CSP 26-003KB (BP022) – ADDENDUM No.02
Gym Renovations and Additions

ADDENDUM

Addendum Number Two (02)
TO PLANS AND SPECIFICATIONS FOR
CSP 26-003KB BP022 Gym Renovations
Fort Bend ISD
STANTEC Project Nos.: 214001246

October 21, 2025

Title
LAYOUT & PAVING PLAN

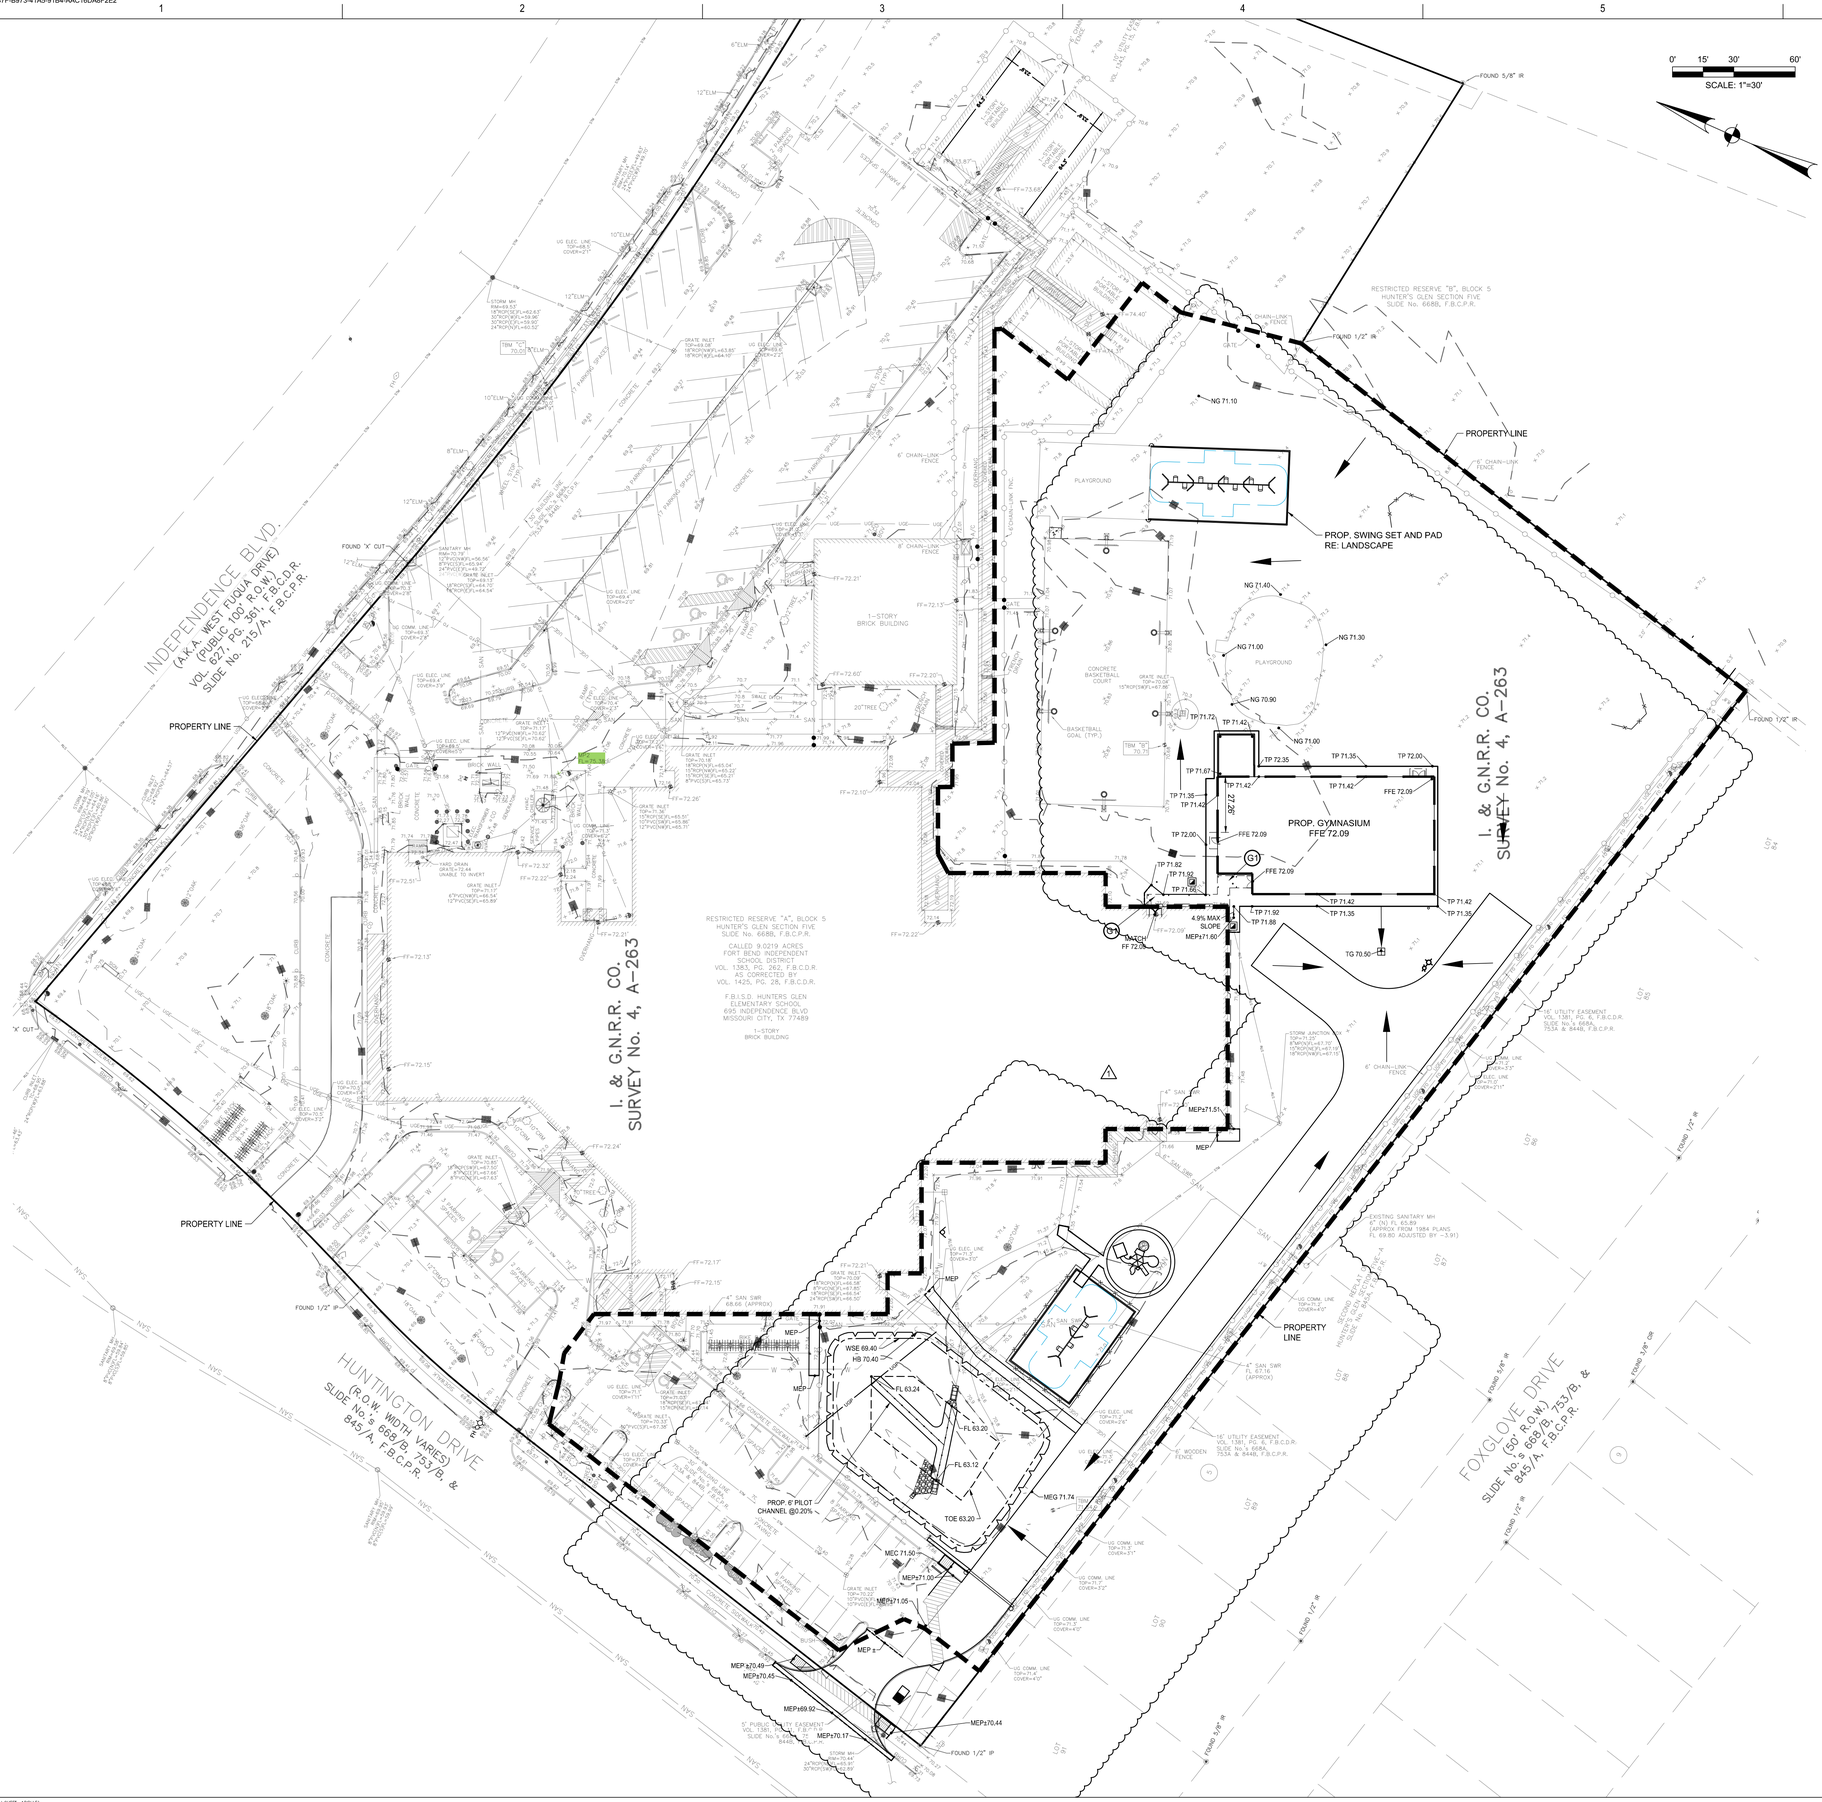
- **a. C100 - HGES DEMOLITION PLAN**
  - i. REMOVED KEY NOTE X3 FOR THE EXISTING GATE THAT IS NOW TO REMAIN.
  - ii. INCLUDED ANOTHER KEY NOTE X2 FOR THE EXISTING FENCE/BACKSTOP TO BE RELOCATED.
  - iii. REMOVED KEY NOTES P2 AND P3 AS SHOWN ON MARKUPS FROM THE 100% BB SESSION
  - iv. REVISED KEY NOTES X2 TO BE X3 AS SHOWN ON MARKUPS FROM THE 100% BB SESSION
- **b. C200 – HGES LAYOUT & PAVING PLAN**
  - i. RELOCATED BACKSTOPS SHOWN AND REFER TO ARCH

Drawing No.
C900 - HGES

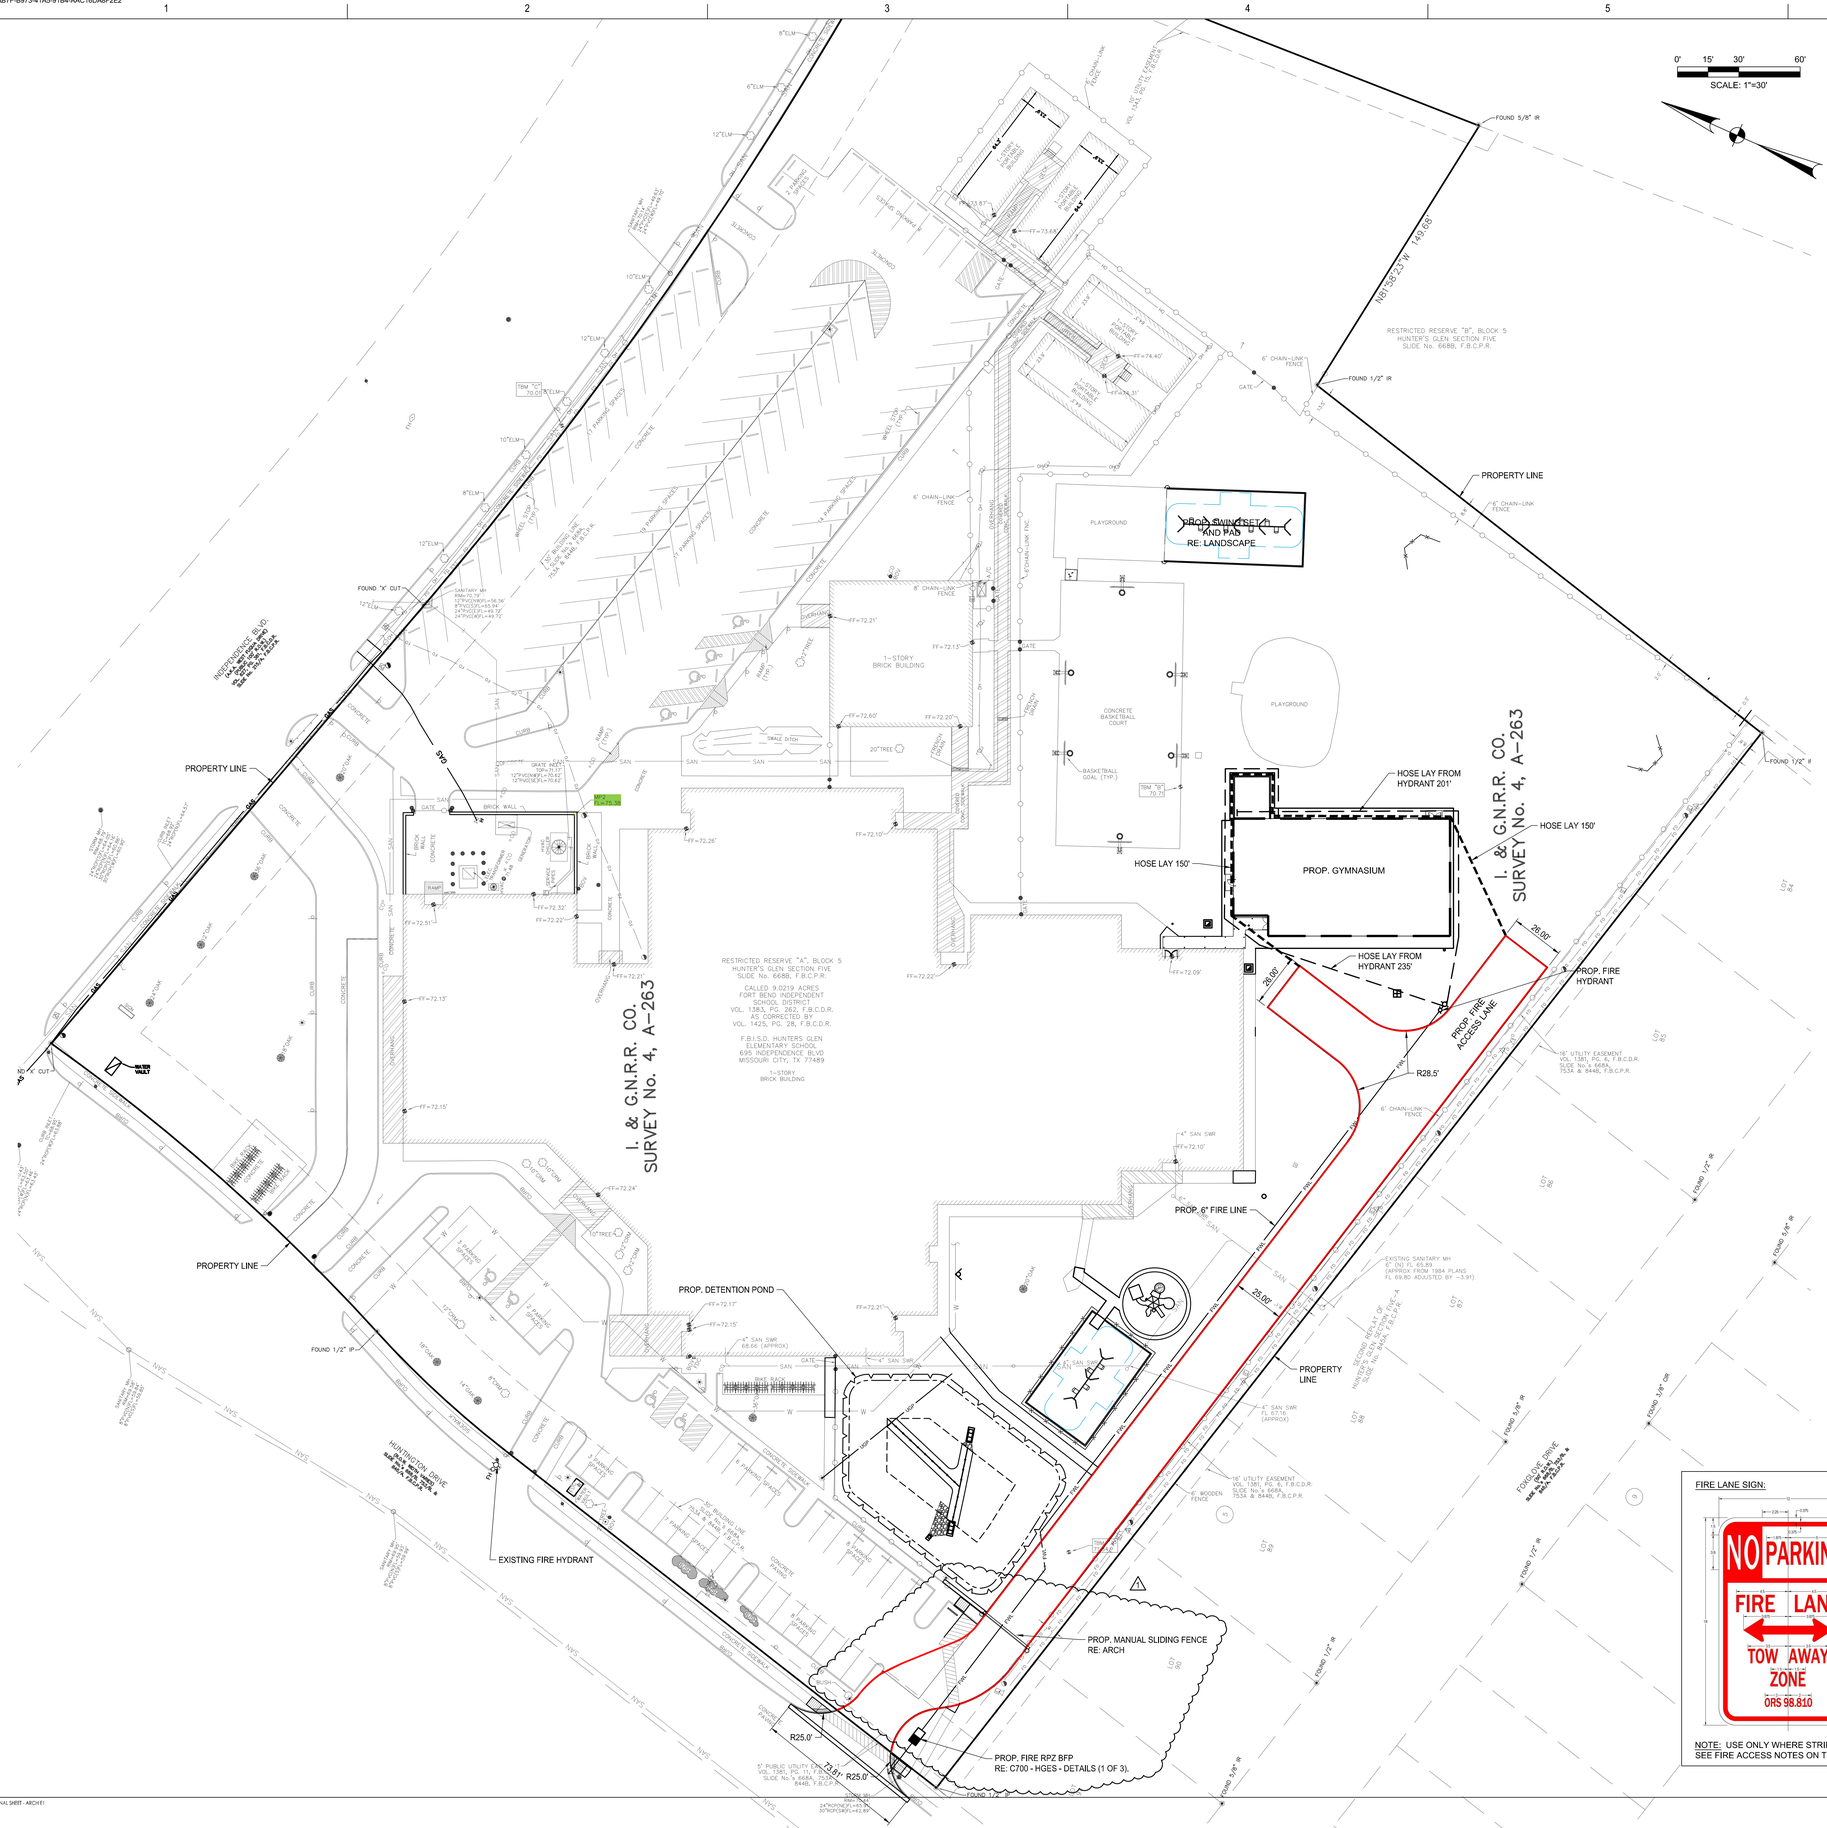
i. C900 – HGES DETAILS (3 OF 3)
i. ADDED NEW SHEET AS "DETAILS (3 OF 3)".
ii. INCLUDED SAFETY END TREATMENT DETAIL.

A1 WALKWAY COVER DETAILS
AS001-HGES 1 1/2" = 1'-0"

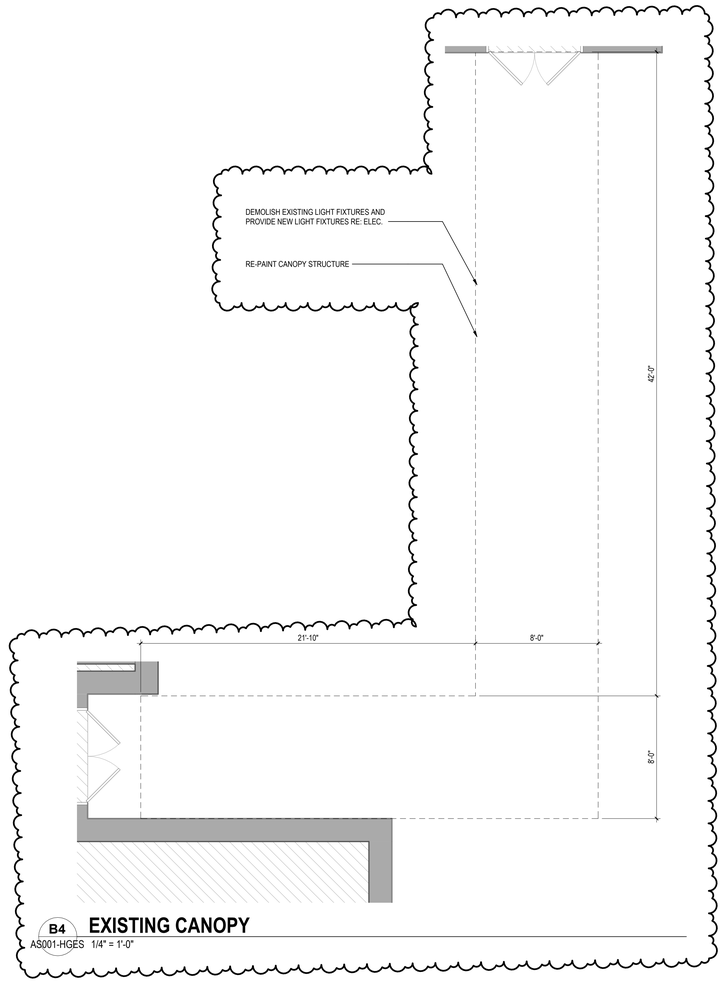
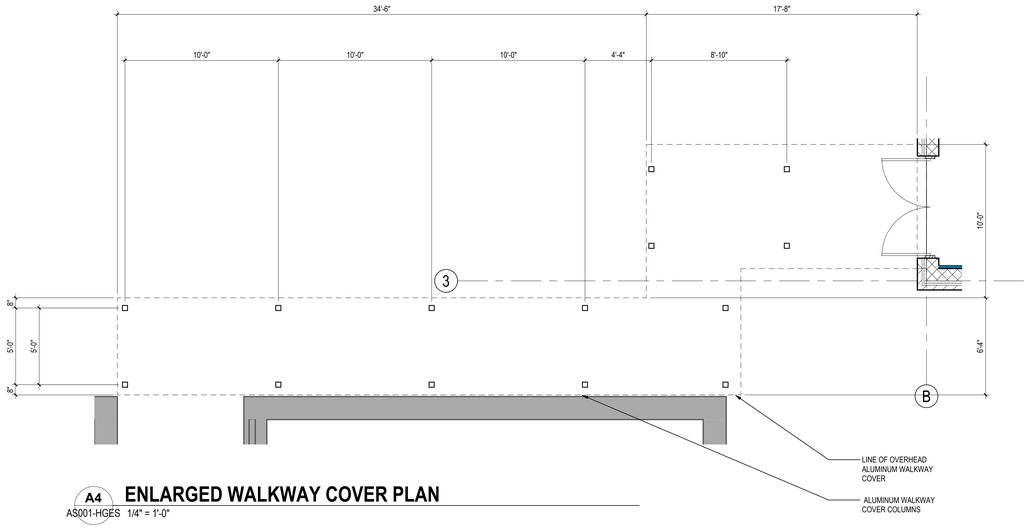
i. ADDED EXISTING ALUMINUM WALKWAY COVER AND DIMENSIONS SO THAT THE INLCUSION OF PAINTING THE ENTIRETY OF THE WALKWAY COVER COULD BE INCLUDED IN COST OF WORK

A1 / AS101 — **ARCHITECTURAL SITE PLAN**
1" = 30'-0"
HGES

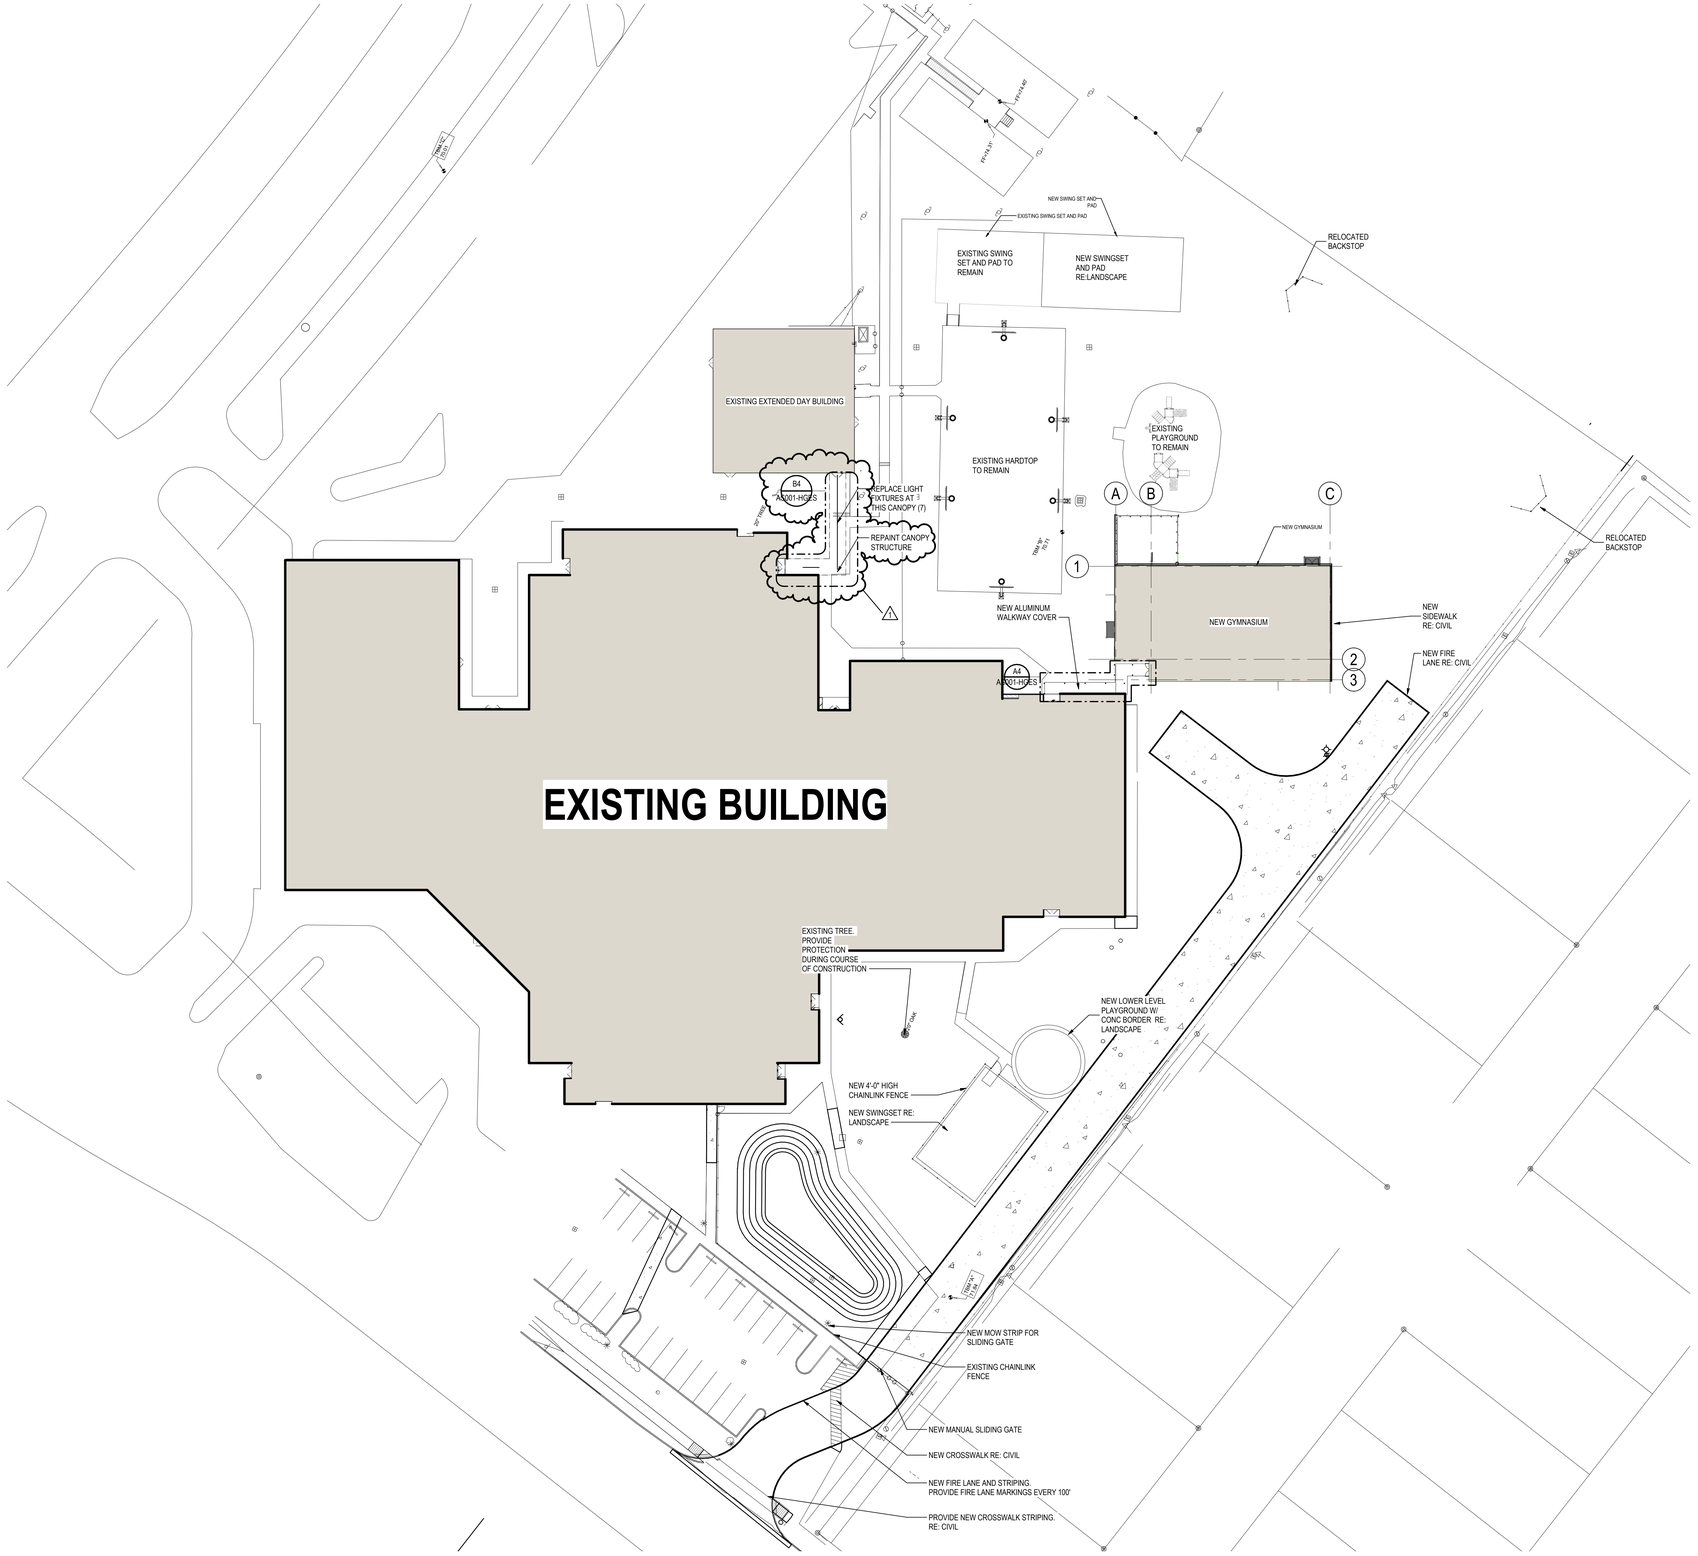
c. **AS101 – HGES ARCHITECTURAL SITE PLAN**
   i. ADDED PAINTING OF THE EXISTING ALUMINUM WALKWAY COVER TO THE SCOPE OF WORK
d. **AS103 – HGES – MOCK-UP WALL**

A103 - HGES

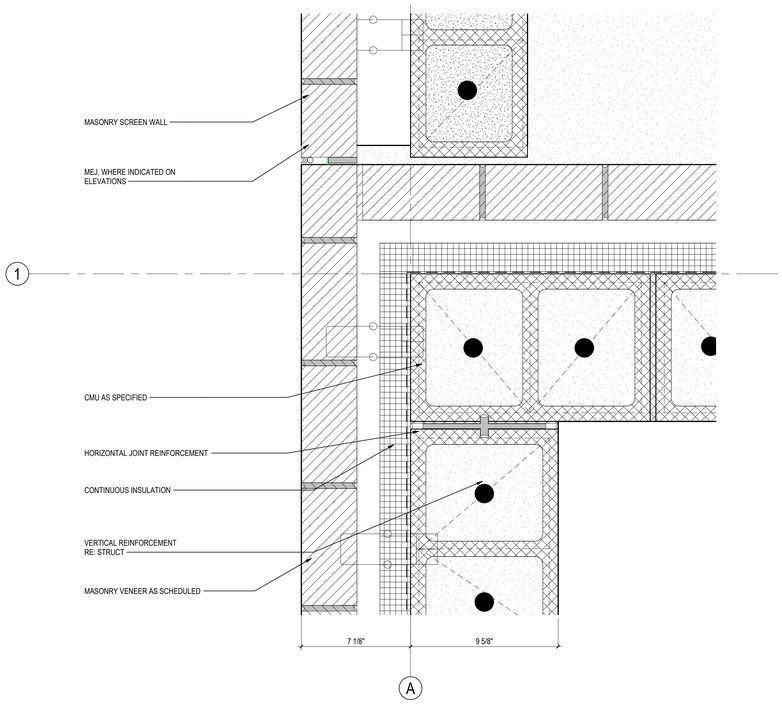
i. ADDED SECTION AND DETAILING OF MOCK-UP WALL
e. **A103 – HGES – FLOOR PLAN -GYMNASIUM**
   i. ADDED PLAN DETAILS
   ii. RECTIFIED DIMENSIONS OF METAL SHELVING IN ROOMS HG102 & HG103
